SUBJECT: POINT BEACH NUCLEAR PLANT, UNITS 1 AND 2 - STAFF ASSESSMENT OF INFORMATION PROVIDED PURSUANT TO TITLE 10 OF THE *CODE OF FEDERAL REGULATIONS* PART 50, SECTION 50.54(f), SEISMIC HAZARD REEVALUATIONS FOR RECOMMENDATION 2.1 OF THE NEAR-TERM TASK FORCE REVIEW OF INSIGHTS FROM THE FUKUSHIMA DAI-ICHI ACCIDENT (TAC NOS. MF3959 AND MF3960)

STAFF ASSESSMENT BY THE OFFICE OF NUCLEAR REACTOR REGULATION
RELATED TO SEISMIC HAZARD AND SCREENING REPORT
POINT BEACH NUCLEAR PLANT, UNITS 1 AND 2
DOCKET NOS. 50-266 and 50-301

Figure 3.3-1 Plot of Staff's and Licensee's Base Case Shear-Wave Velocity Profiles for the Point Beach Site

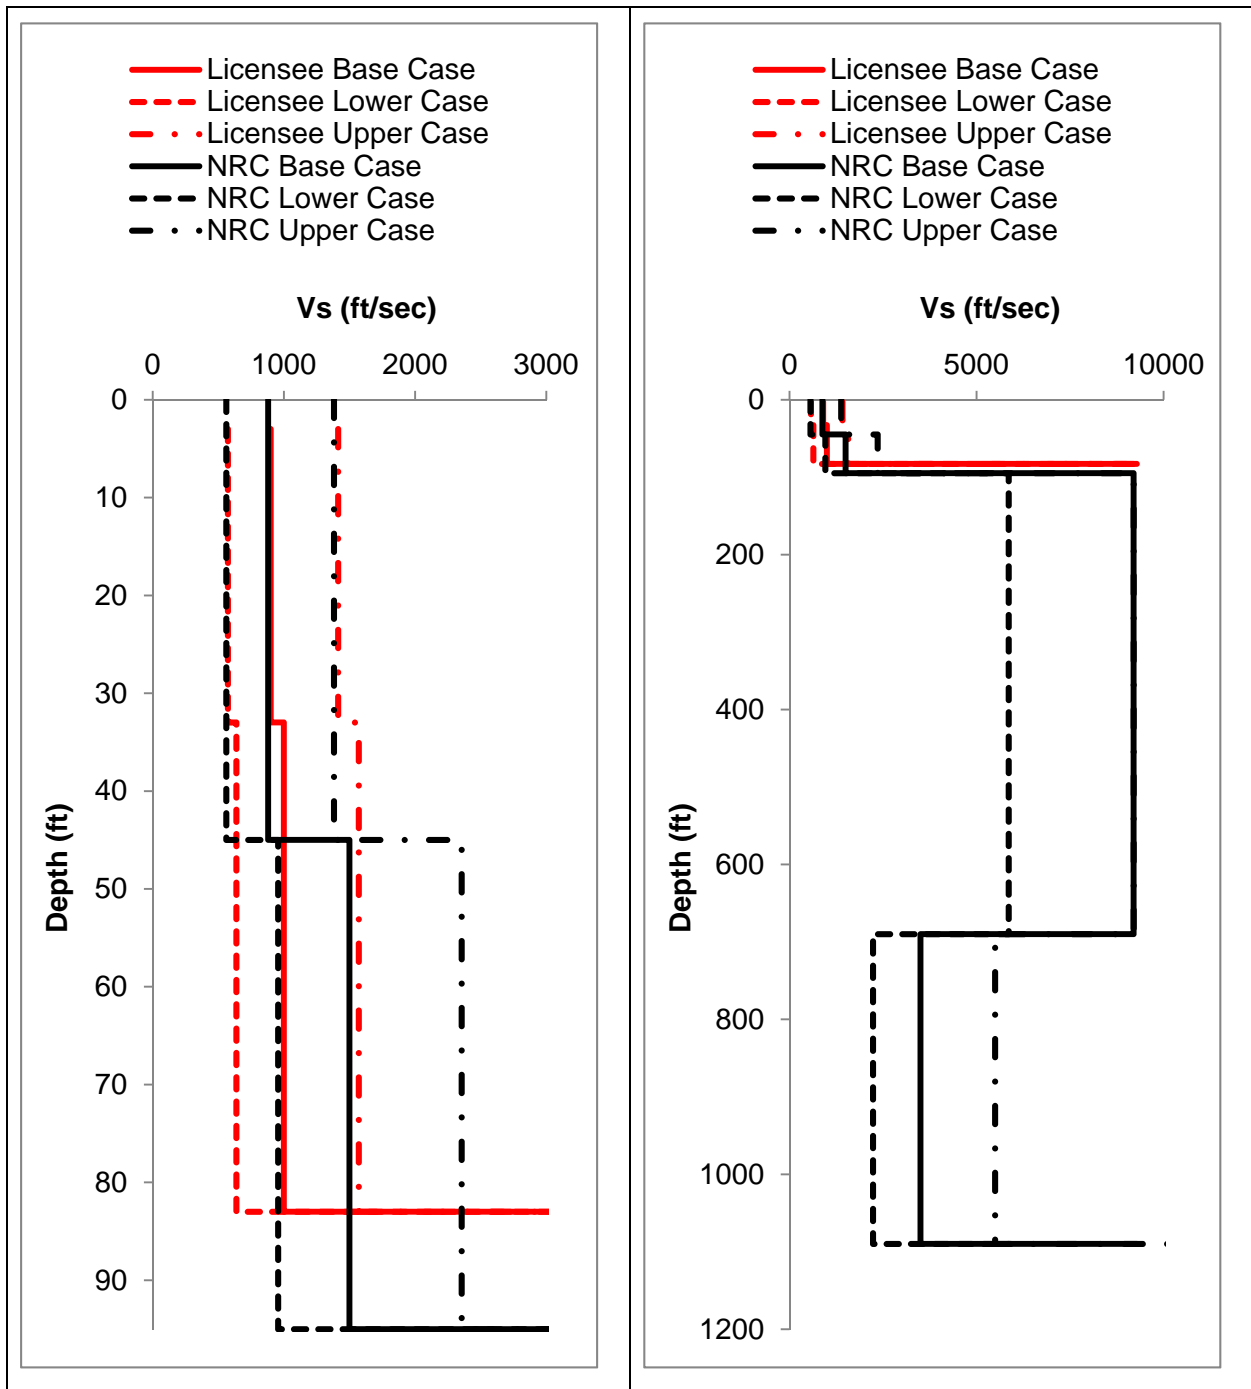
Using these measured shear-wave velocity estimates, along with guidance provided in the SPID, the licensee developed the best-estimate shear-wave velocity profile. The licensee also developed upper and lower base case profiles using a scale factor of 1.57, which implies a natural log standard deviation of 0.35, following guidance in the SPID. This approach to developing base case profiles resulted in three profiles, which are shown below in Figure 3.3-1 of this assessment.

To confirm the licensee's site response analysis, the NRC staff performed site response calculations for the Point Beach site. The NRC staff independently developed three base case shear-wave velocity profiles from information provided in UFSAR. The NRC staff developed three separate profiles in order to capture the epistemic uncertainty in the shear wave velocity of the subsurface layers. The NRC staff's base case shear-wave velocity profiles are shown along with the licensee's base case profiles in Figure 3.3-1 of this assessment. The NRC staff's shear wave velocity profiles agree well with those submitted by the licensee over the upper 80 ft (24 m) where the licensee's profile encounters bedrock. The NRC staff's profile continues to a depth of 1100 ft (335 m) in order to account for the lower velocity Maquoketa formation that the general geology suggests lies beneath the higher velocity Niagara formation. The NRC staff considered shear wave velocity information for the Maquoketa formation from other nuclear

Using the guidance provided in the SPID for the determination of site kappa resulted in values of 0.010 sec, 0.015 sec and 0.007 sec for the base, lower and upper base case profiles, respectively. These values are slightly higher than the licensee's values due to the additional depth to base rock in the NRC staff's profiles. In addition, to account for the aleatory variability in material properties across the plant site, the NRC staff randomized its base case shear-wave velocity profiles following the SPID guidance provided in Appendix B of the SPID.

Figure 3.3- 1 Plot Comparing the NRC staff's and the Licensee's Median Amplification Functions and Uncertainties for the Point Beach site.

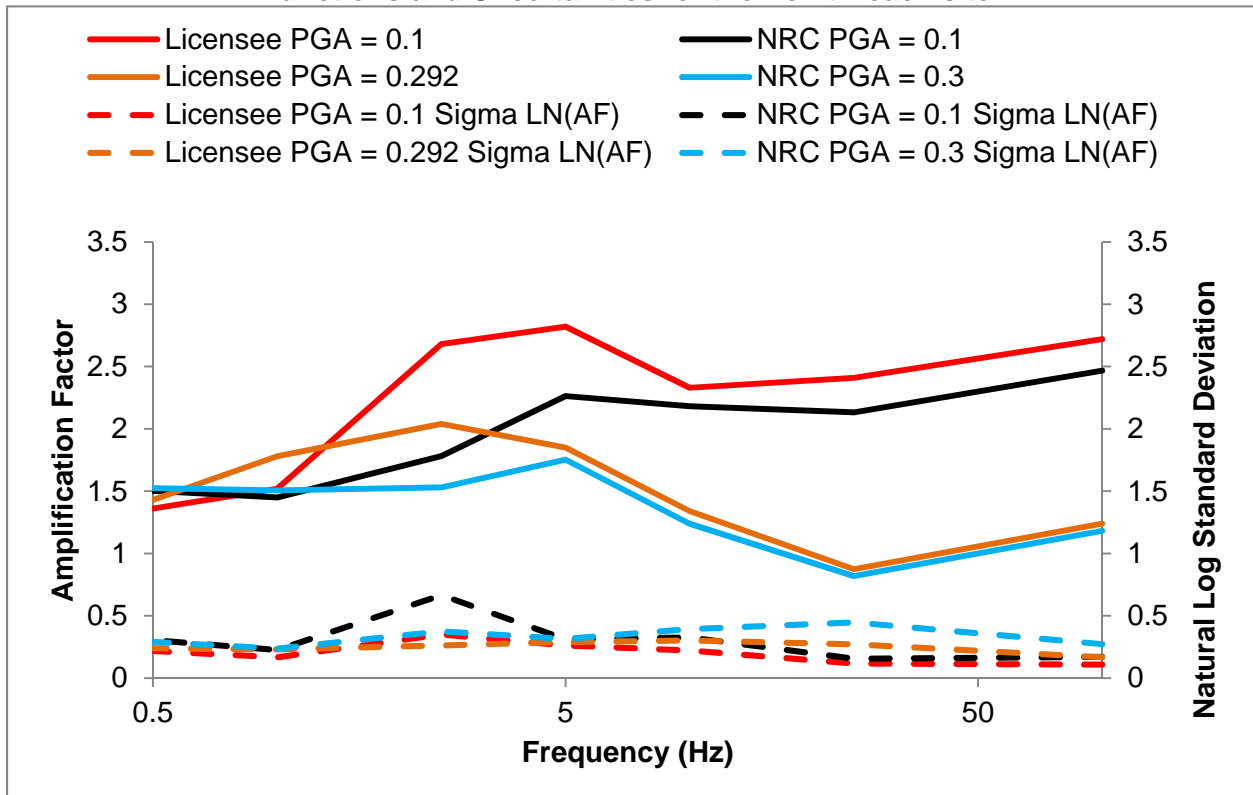
In order to calculate control point hazard curves for the Point Beach site, the licensee and NRC staff developed median amplification functions for the site for several different loading levels. The median site amplification and associated uncertainty for two separate loading levels are shown in Figure 3.3-2 of this assessment. It can be seen that both the NRC staff's and licensee's site amplifications are similar in shape with small differences at peak amplification, which is due to the more shallow subsurface profile used by the licensee. The licensee's and staff's control point hazard curves resulting from the convolution of the site amplification with the PSHA rock hazard are shown in Figure 3.3-3 of this assessment. As shown in Figure 3.3-3, the licensee's and staff's control point hazard curves for the Point Beach site are very similar.

Figure 3.3-2 Plot Comparing the NRC staff's and the Licensee's Mean Control Point Hazard Curves at a Variety of Frequencies for the Point Beach site

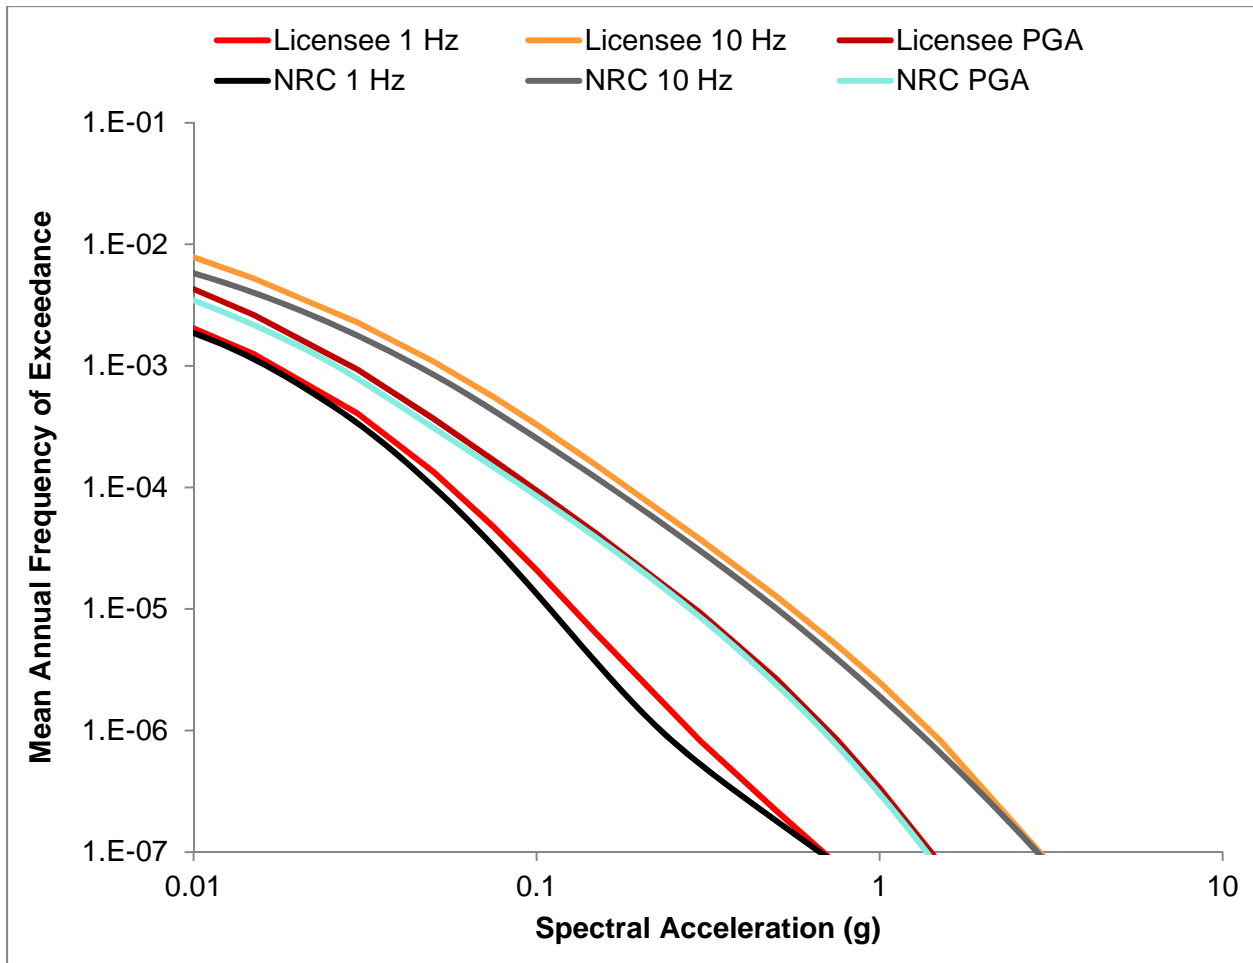
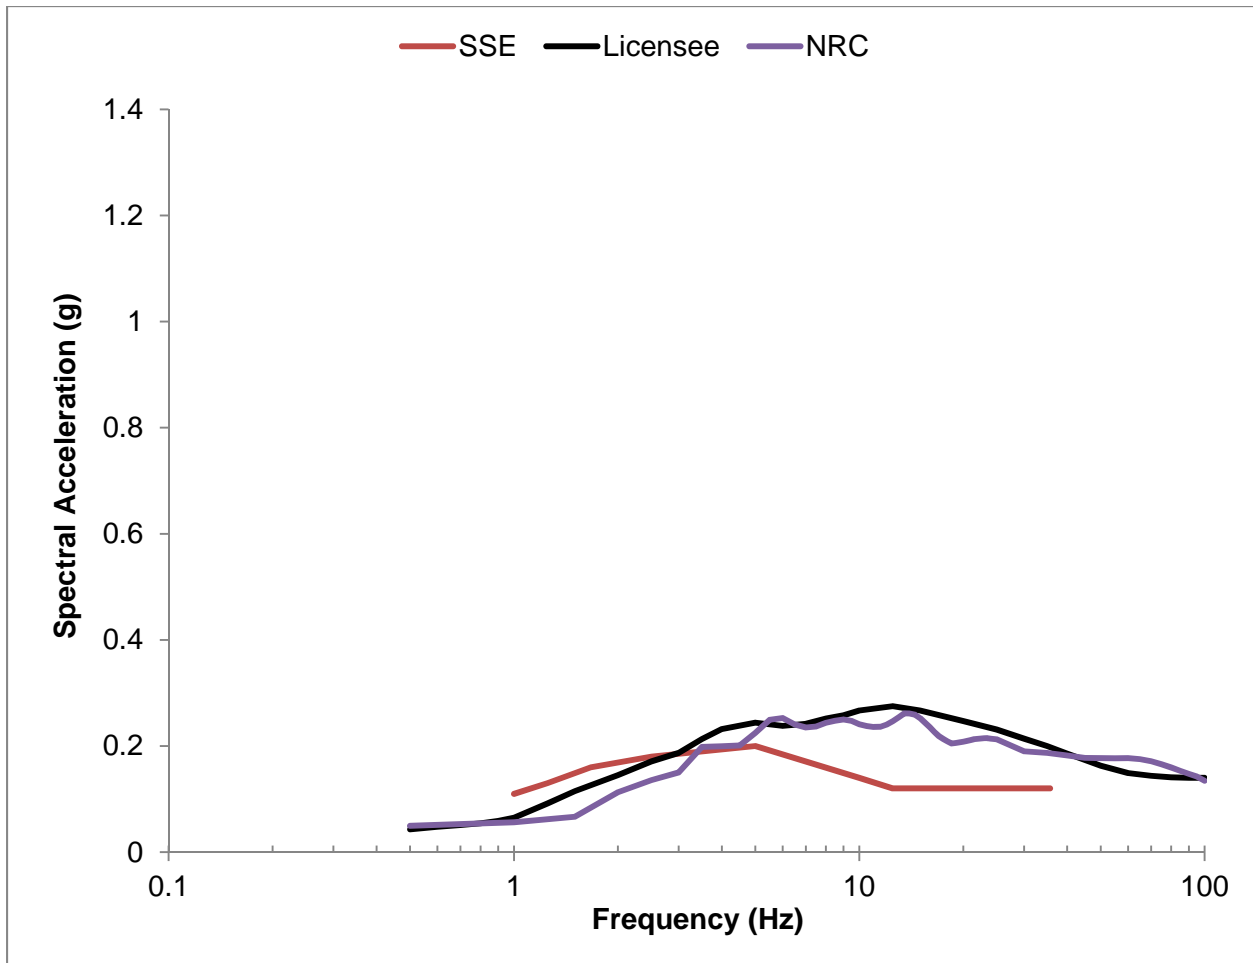
In summary, the NRC staff concludes that the licensee's site response was conducted using present-day guidance and methodology, including the NRC-endorsed SPID. The NRC staff performed independent calculations to confirm that the licensee's amplification factors and control point hazard curves adequately characterize the site response, including the uncertainty associated with the subsurface material properties, for the Point Beach site.
